Re: Expansion of Waste Rock Site, Task ID# 4982, Canyon Fuel Company, LLC, Sufco Mine

Technical Analysis and Findings

PID: C0410002
TaskID: 4982
Mine Name: SUFCO MINE
Title: WASTE ROCK SITE EXPANSION

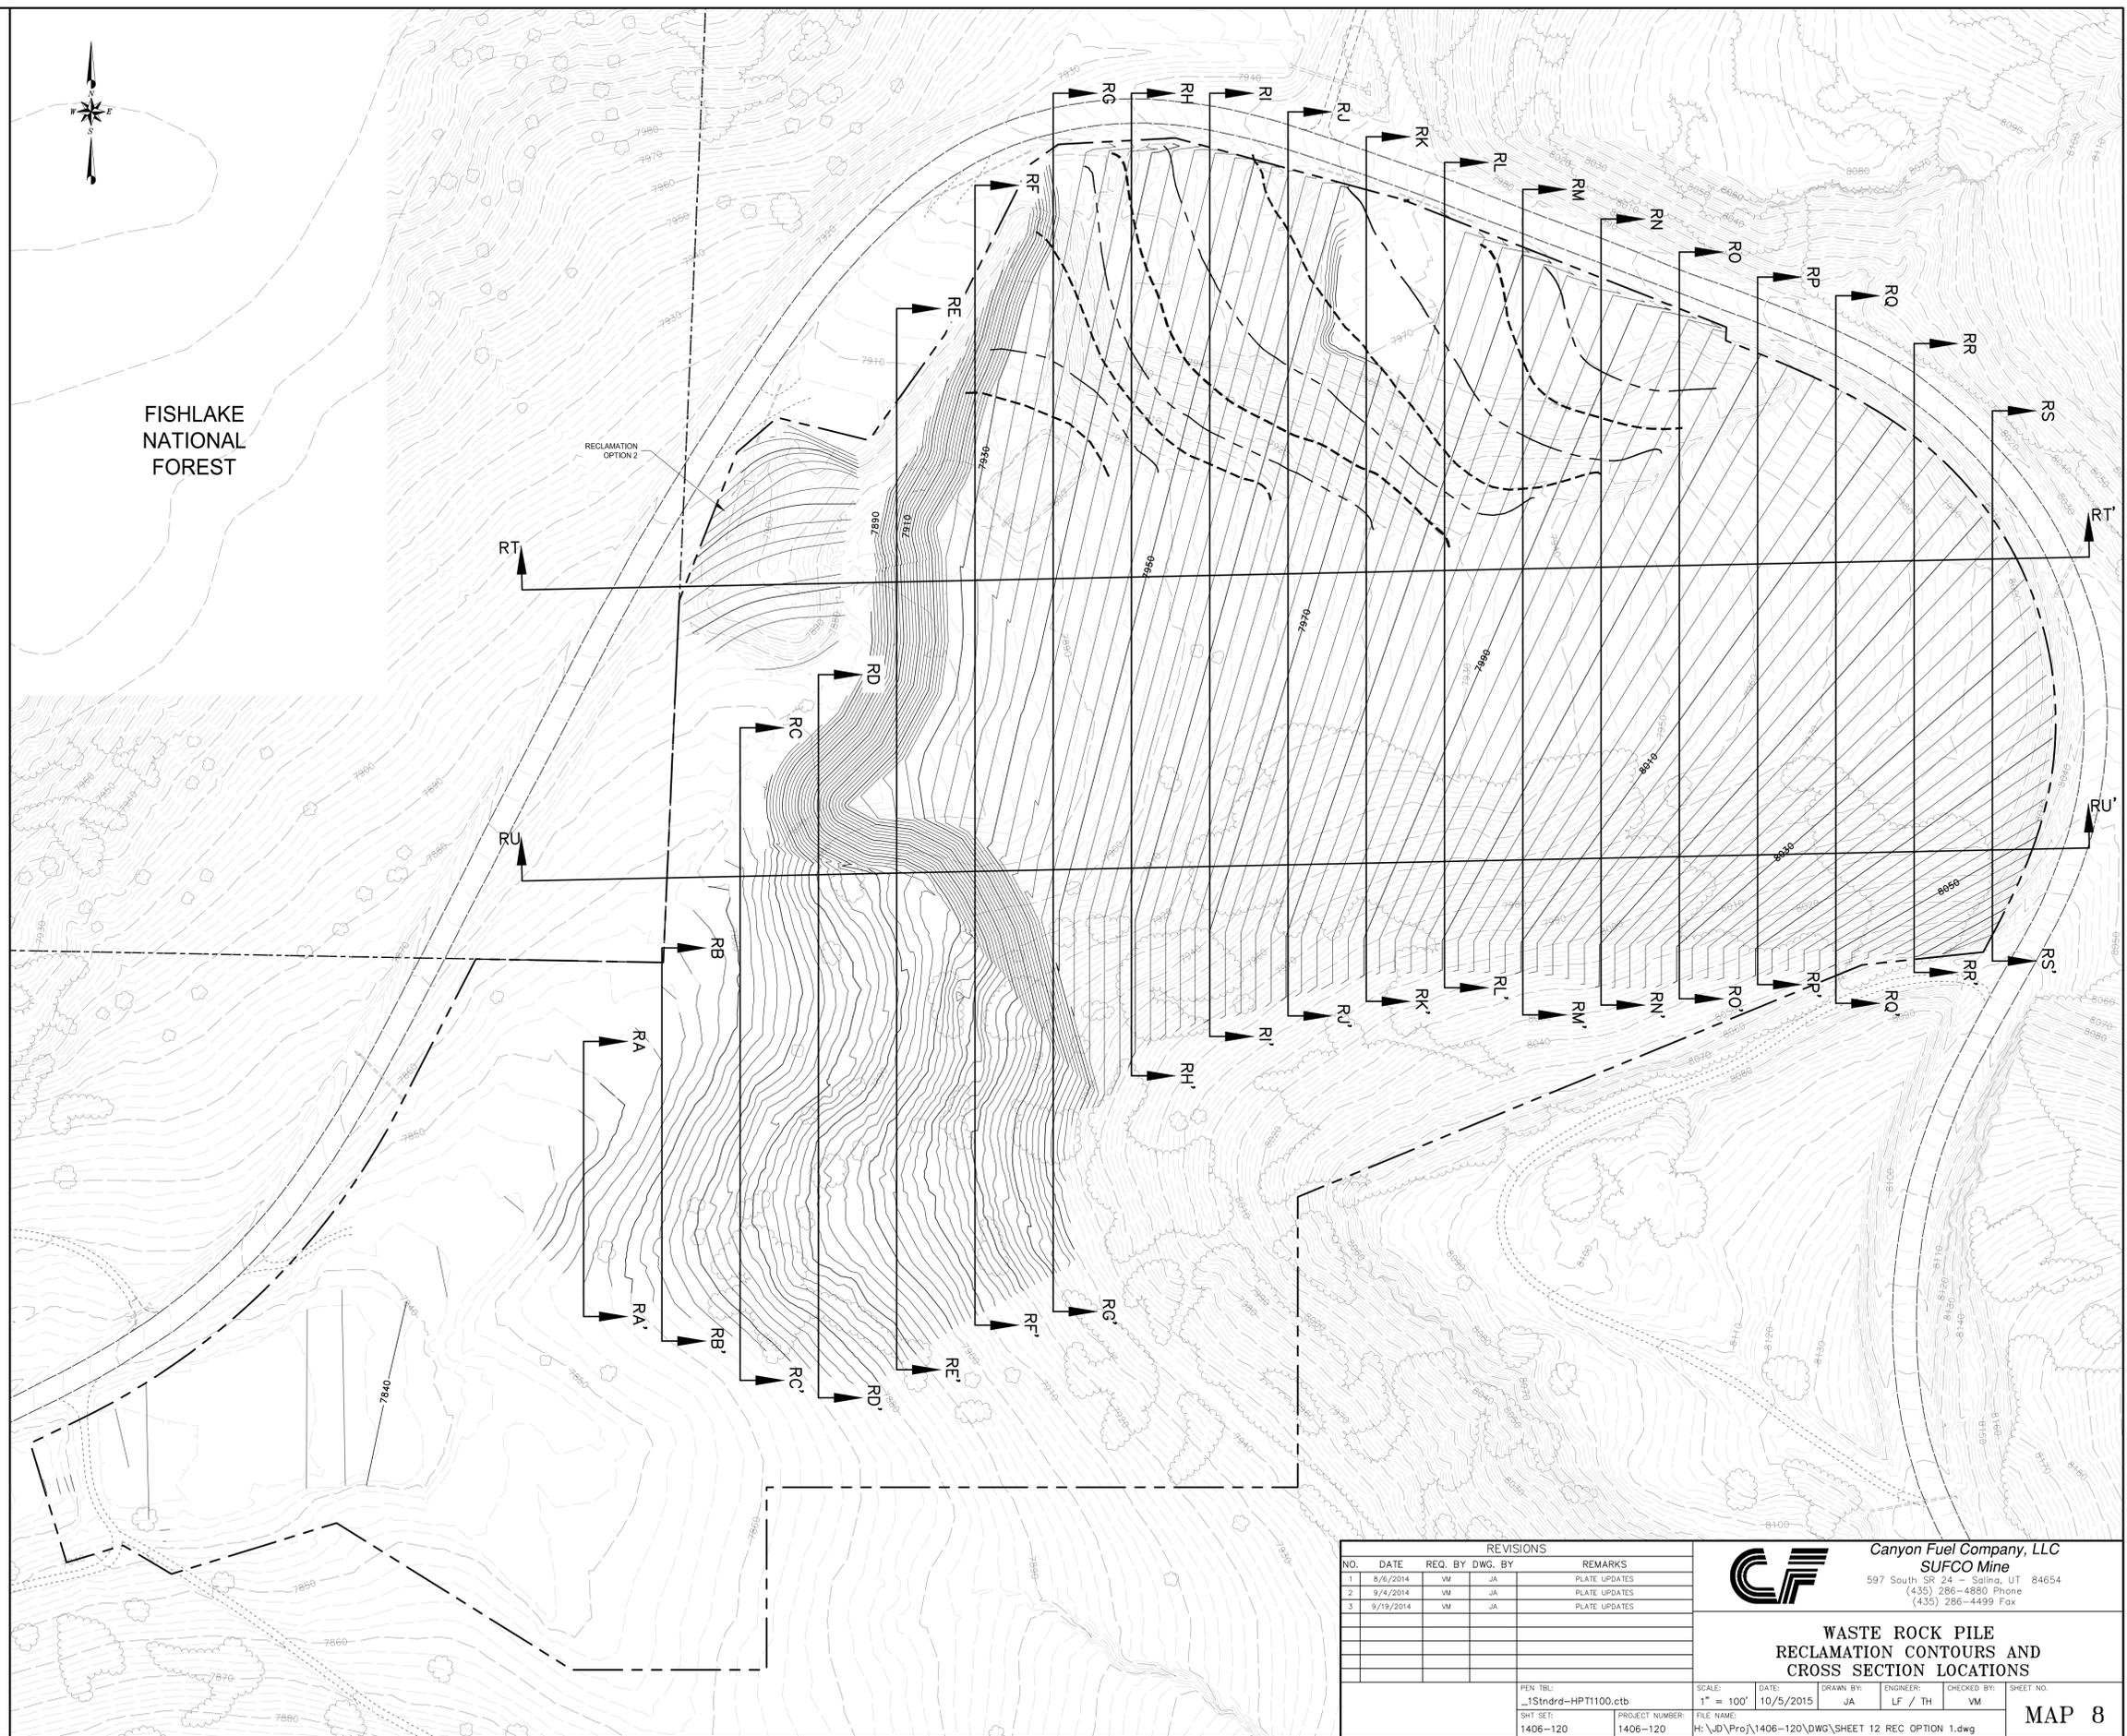
R645-301-242.100, Final reclamation Map 8 must show all stockpiled subsoil as redistributed.
